## HISTORIC AND DESIGN REVIEW COMMISSION

Agenda Item No: 21

**HDRC CASE NO:** 2016-452  
**COMMON NAME:** 100 N Main  
**LEGAL DESCRIPTION:** NCB 909 BLK LOT A8 & A 9  
**ZONING:** D S H HE RIO-3  
**CITY COUNCIL DIST.:** 1  
**DISTRICT:** Main/Military Plaza Historic District  
**LANDMARK:** Bell Furniture / Wolfson's  
**APPLICANT:** Randy Kelly/JRK Design  
**OWNER:** REM Hospitality  
**TYPE OF WORK:** Approval of signage master plan, landscaping, street level elements  
**REQUEST:**

The applicant is requesting a Certificate of Appropriateness for outstanding items specific to the new construction at 100 N Main. At this time, the applicant is requesting a Certificate of Appropriateness for:

sheet description  
**SITE AND PAVING PLAN**  
sheet number  
C1.02

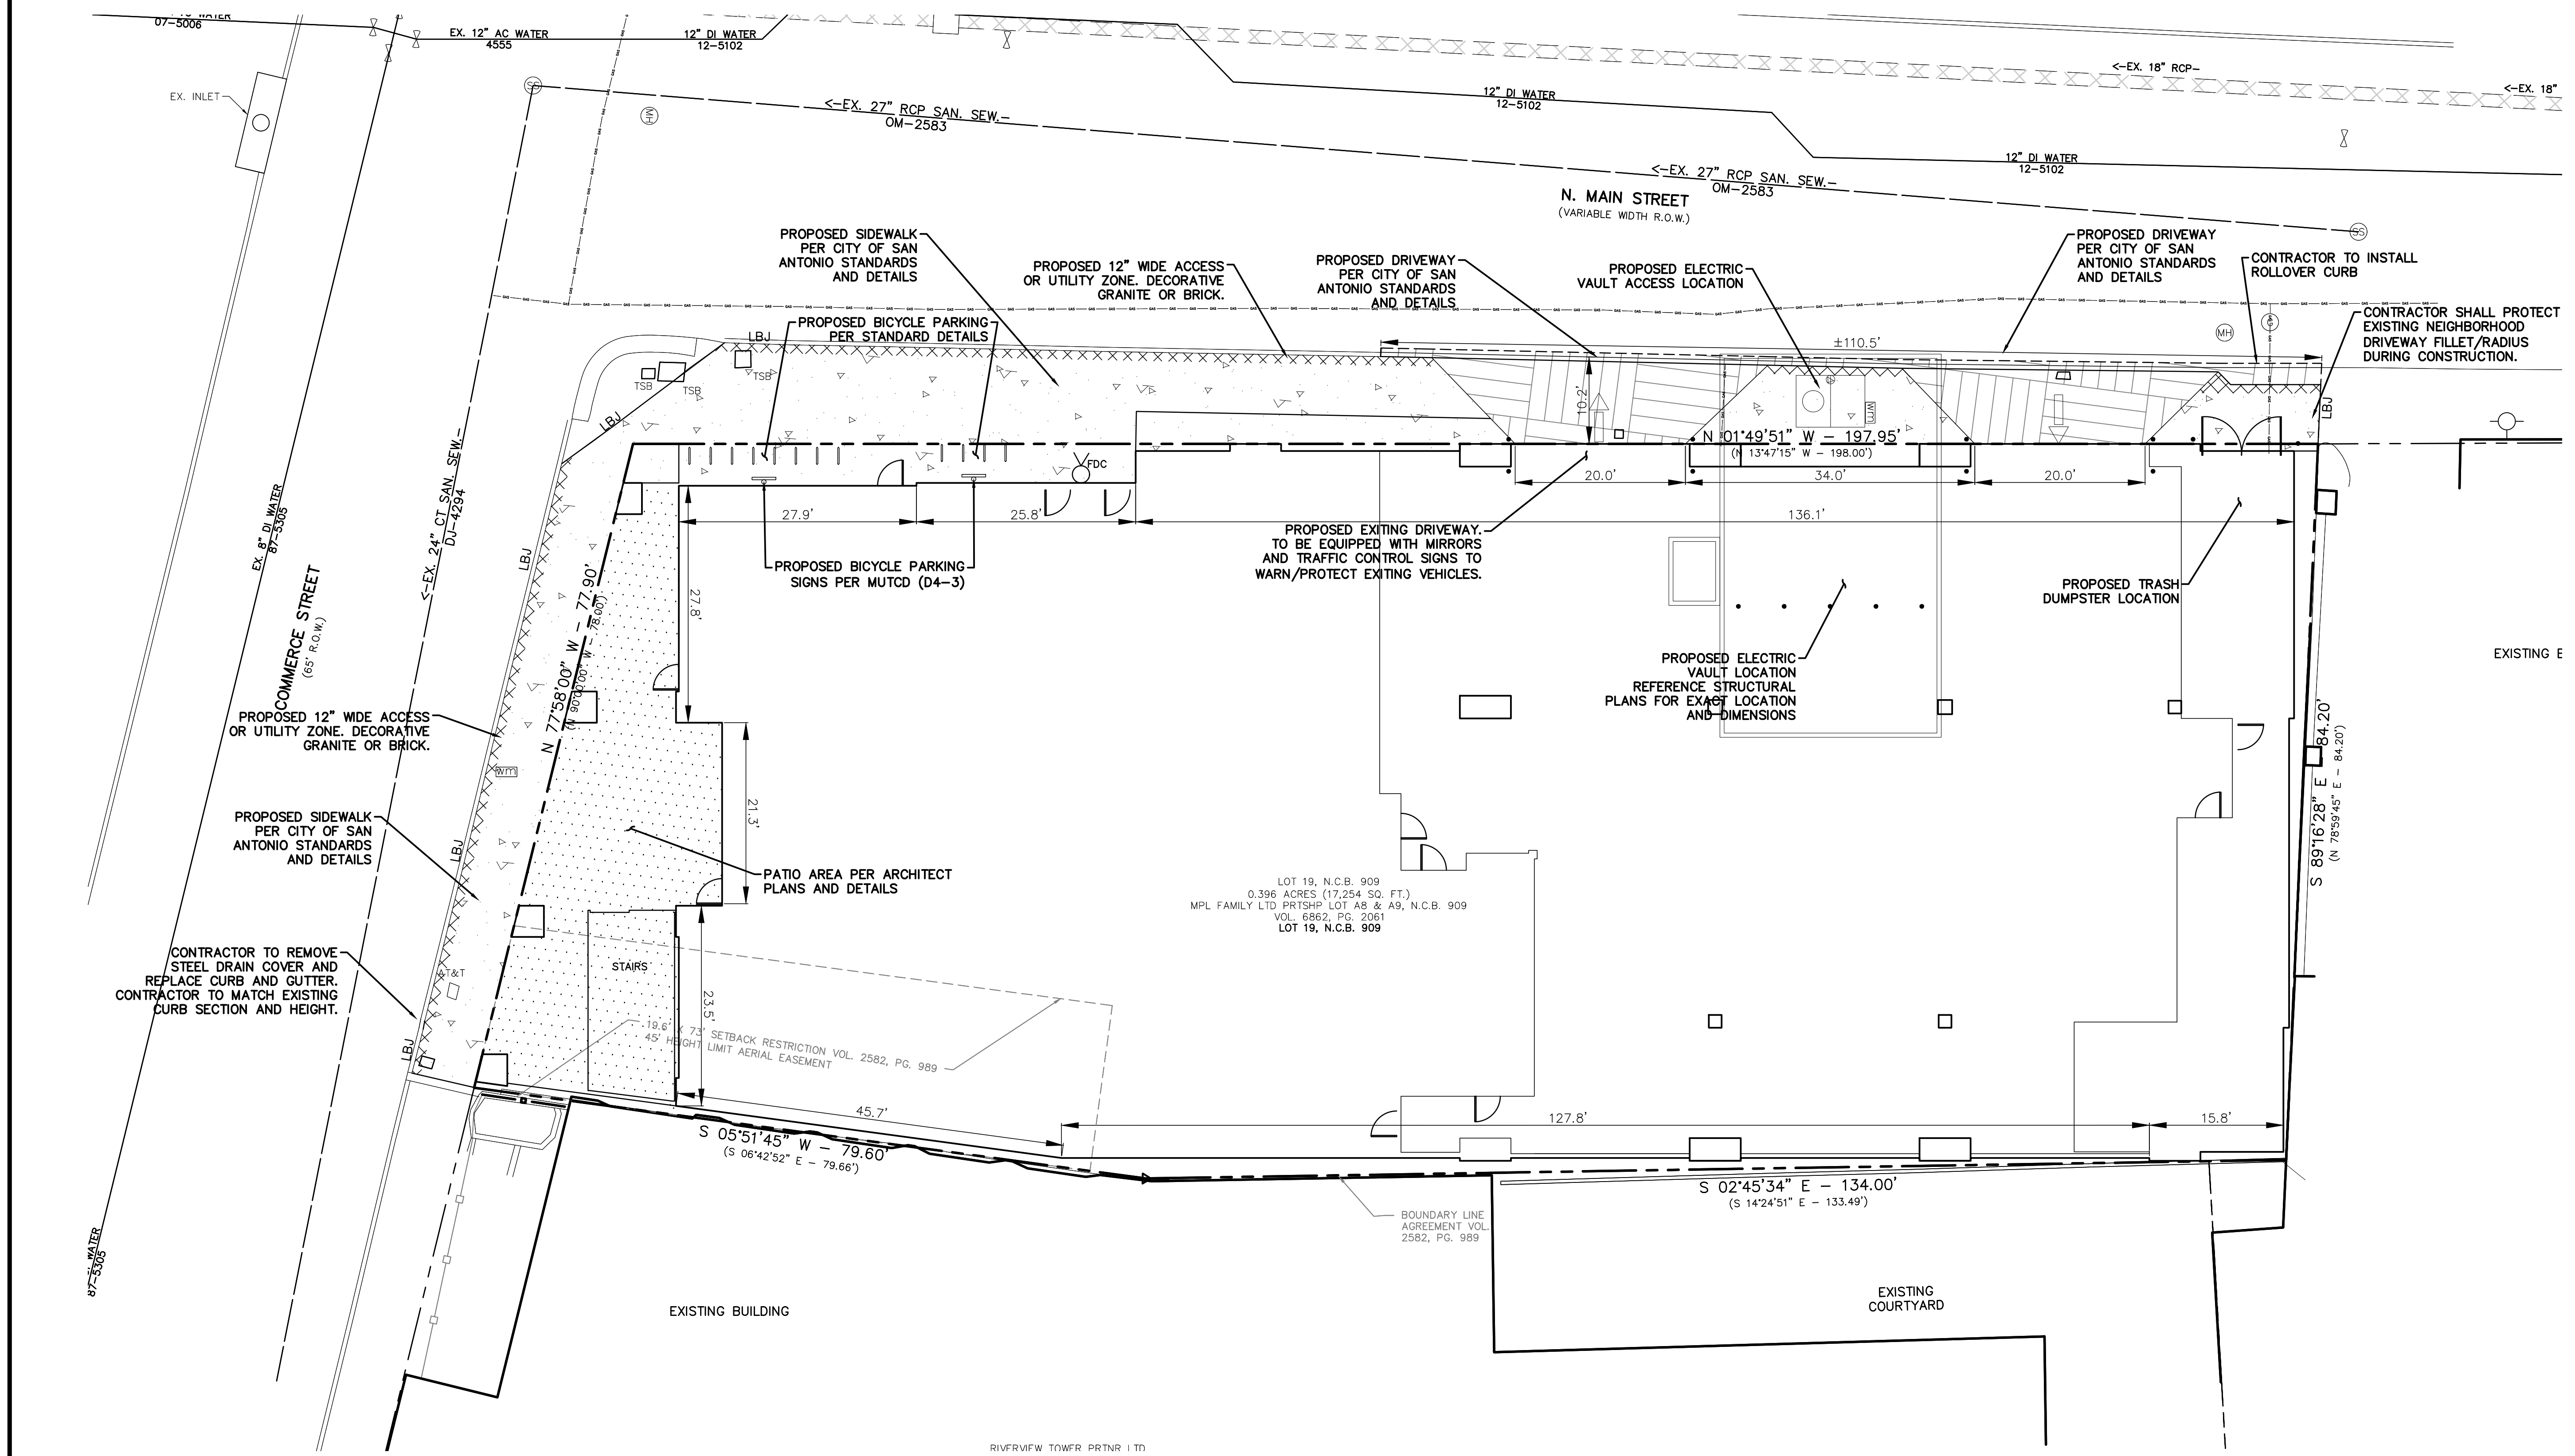
- c. SIDEWALK DETAIL – The applicant previously proposed to incorporate curb cuts along N Main which would require pedestrians to step down from sidewalks to cross the curb cuts, potentially disturbing the flow of pedestrian traffic. The applicant has provided a set of civil documents that note the sidewalk remaining at a constant level. Staff finds this proposal appropriate.

01 LANDSCAPE PLAN  
SCALE: 1" = 10'-0"

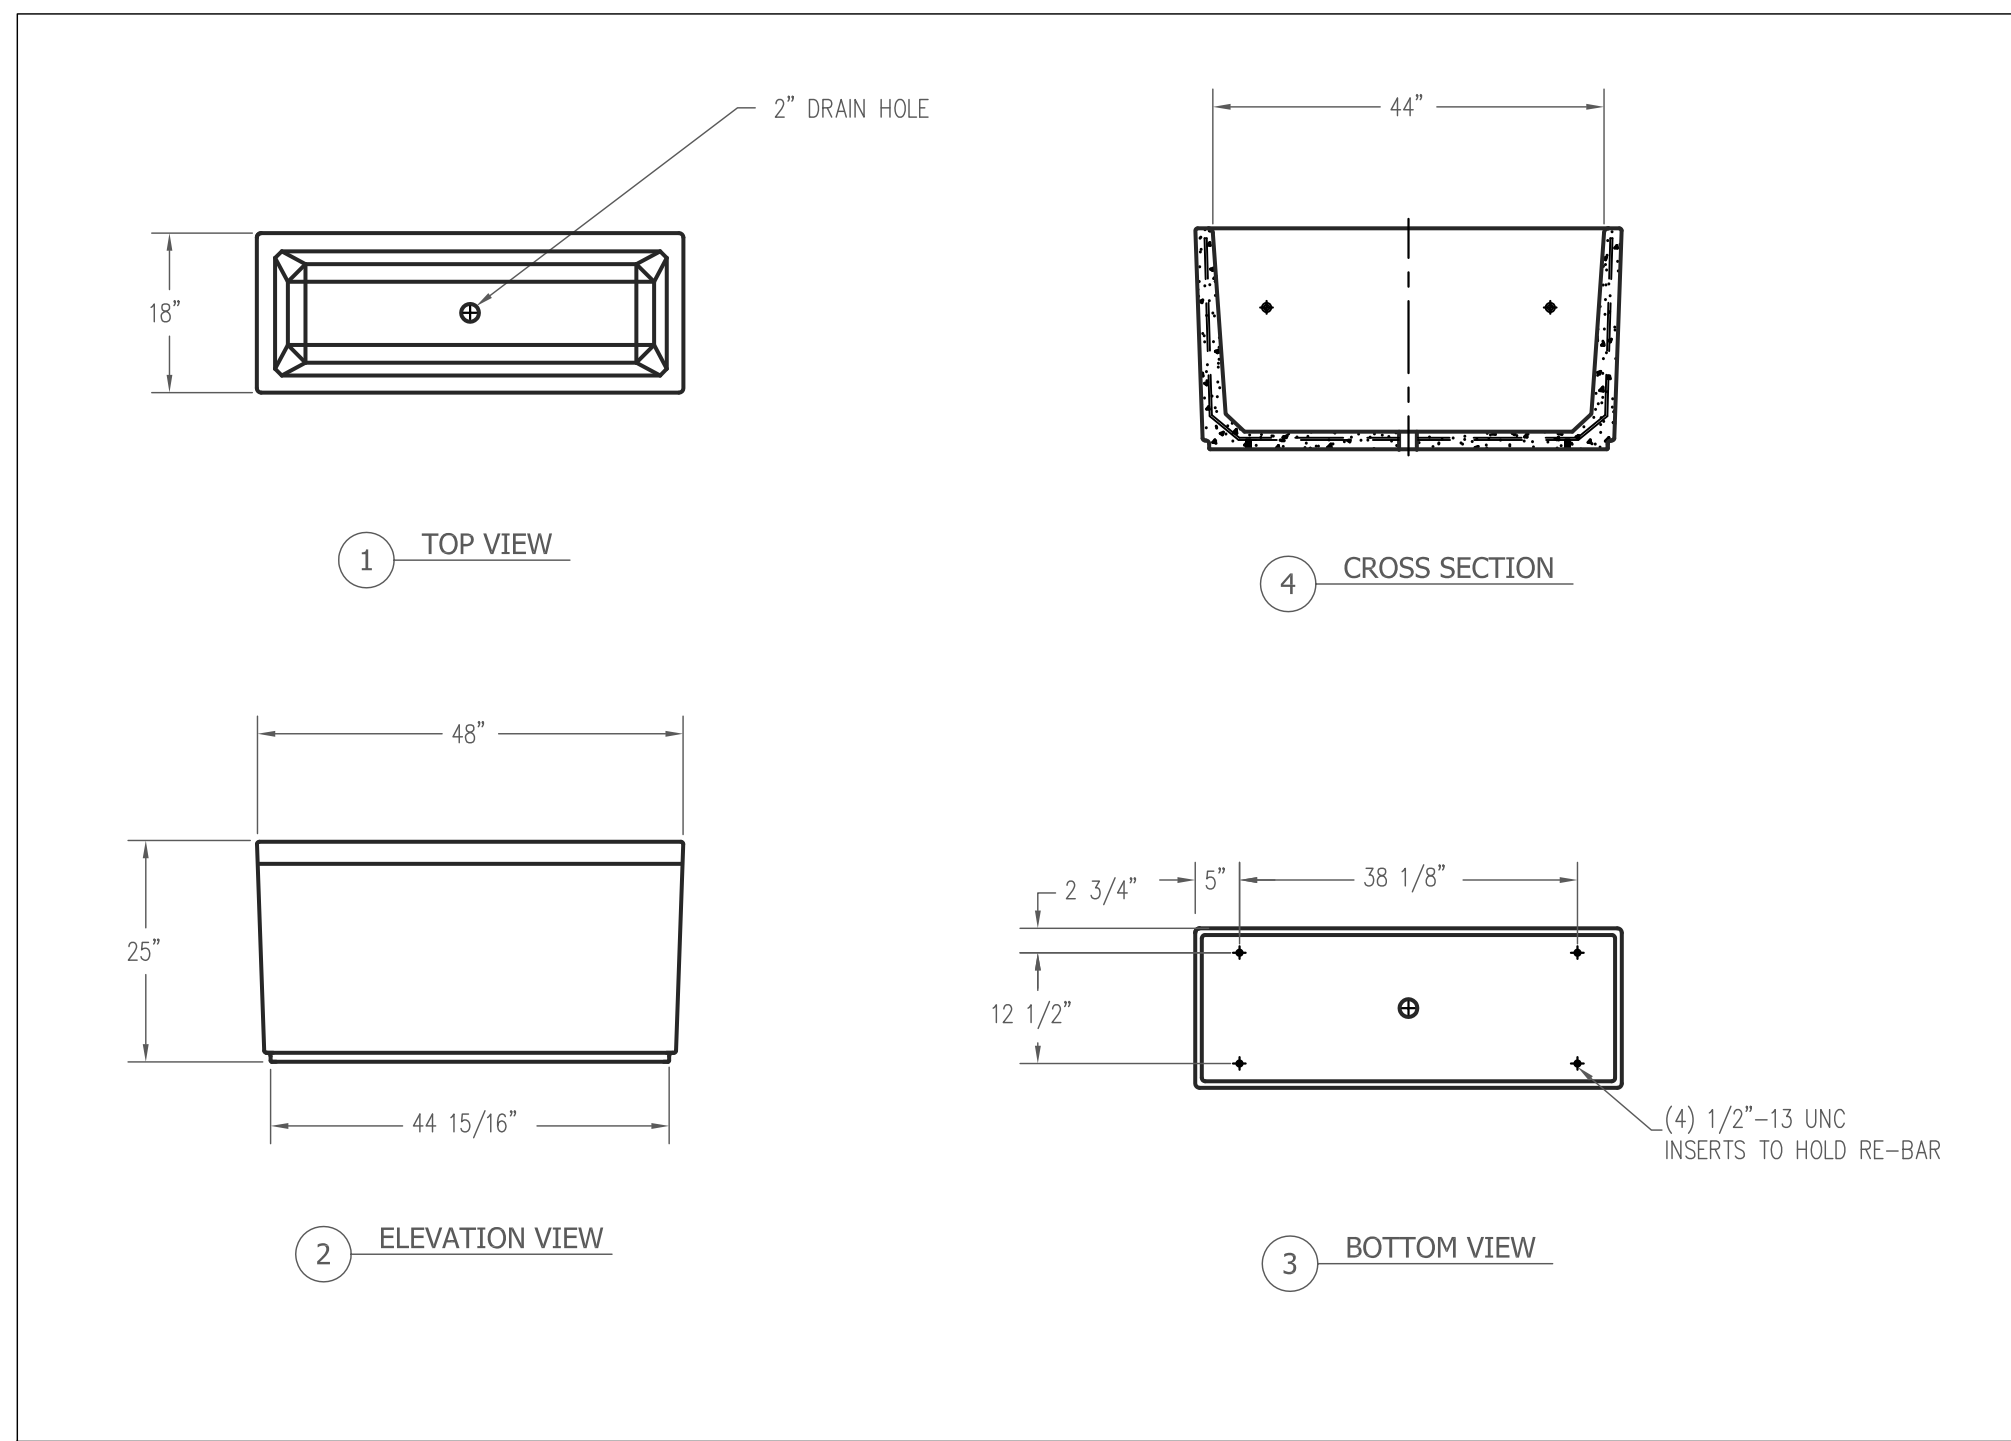
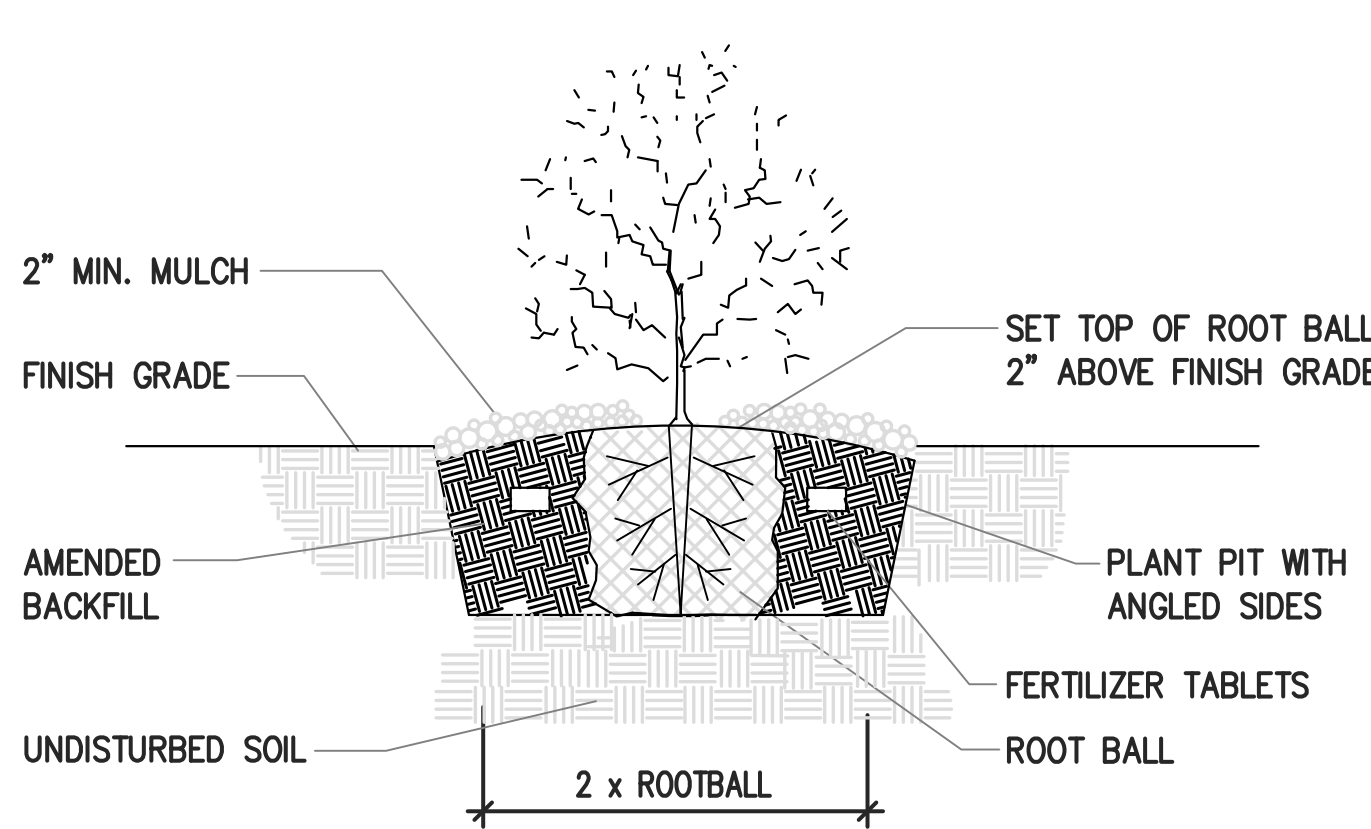
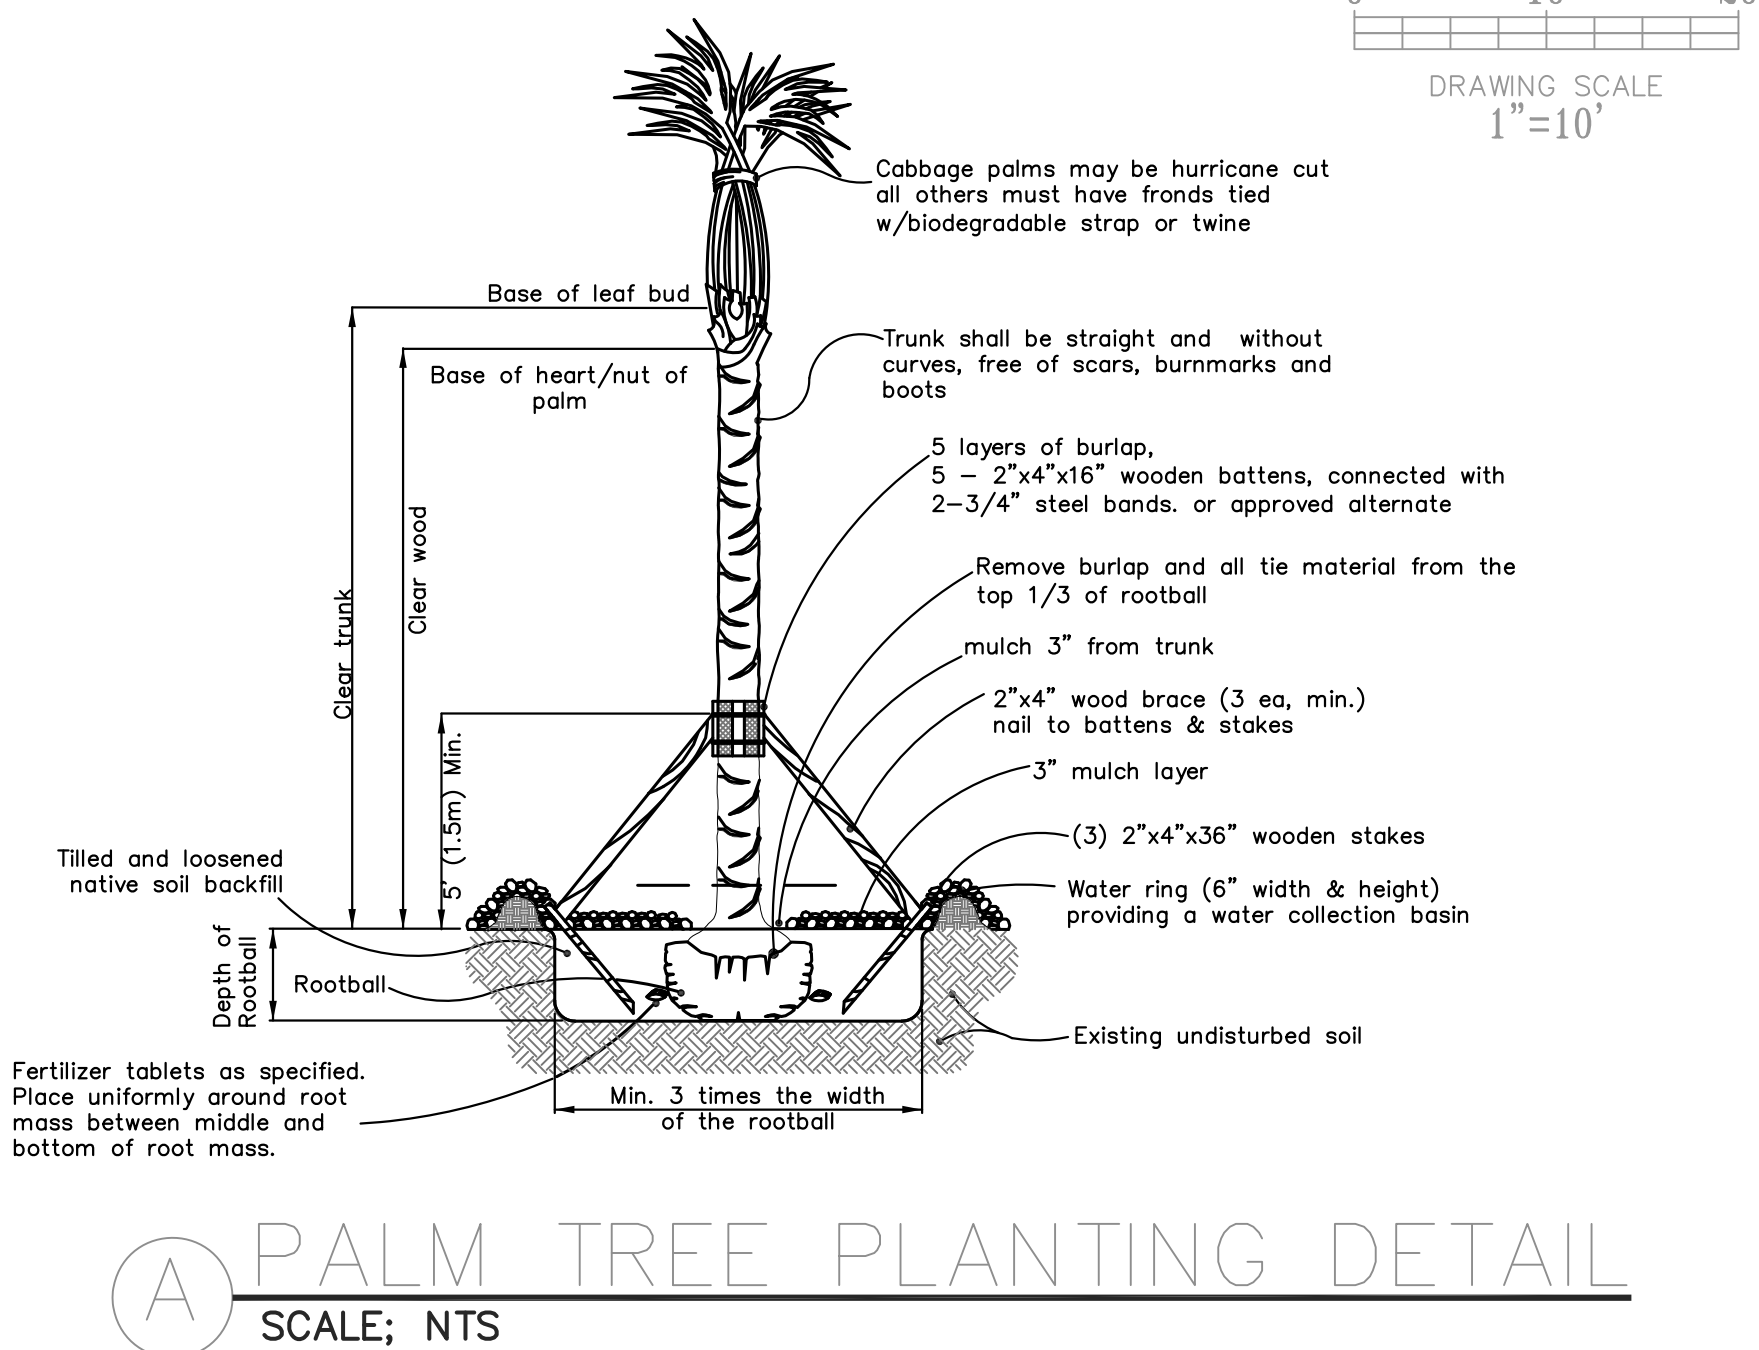
- d. LANDSCAPING PLAN – The applicant has provided staff with a landscaping plan that notes the installation of various plant materials within raised planters along the public right of way at E Commerce and N Main and the installation of bicycle racks along N Main. This is consistent with the UDC Section 35-672. Additionally, the applicant has provided a detailed list of landscaping materials including shrubbery, vines, blooming plants and ornamental grasses. Staff finds the applicant's proposed landscaping materials appropriate and consistent with the UDC.
